Category: Sunroof

Document Number: PI002BC

Description: New Recommended Wiring Layout (Soft Touch Equipped Sunroofs)

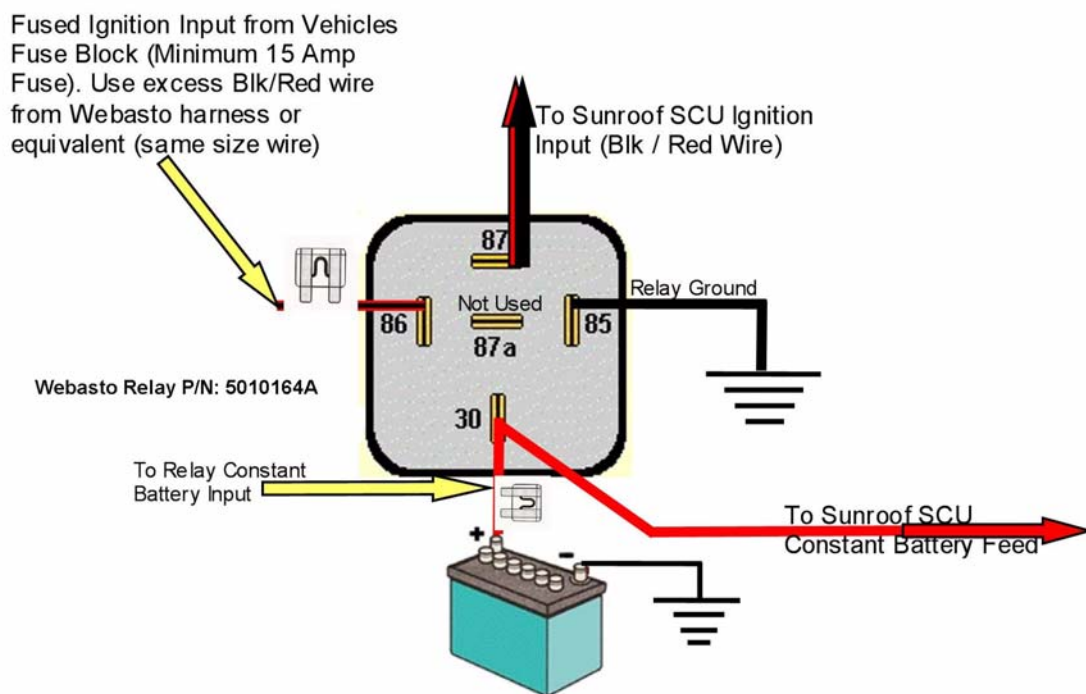
This bulletin covers the new recommended wiring procedure for all Inbuilt and Spoiler soft touch sunroof applications. The stand alone design will reduce the integration into the vehicles wiring system. This allows the sunroof to draw directly from source battery power while removing the potential of unpredictable results caused by tapping into a vehicles electrical system. Please refer to the text and diagrams below.

RELAY WIRING:

Terminal 30 - (SPliced CONNECTION)

- Constant Battery Input To Relay
- Battery Output To Sunroof SCU

Terminal 85 - Relay Ground

Terminal 86 - Input From Existing Ignition Source

Terminal 87 - Ignition Output to Sunroof SCU

Terminal 87a - Not Used
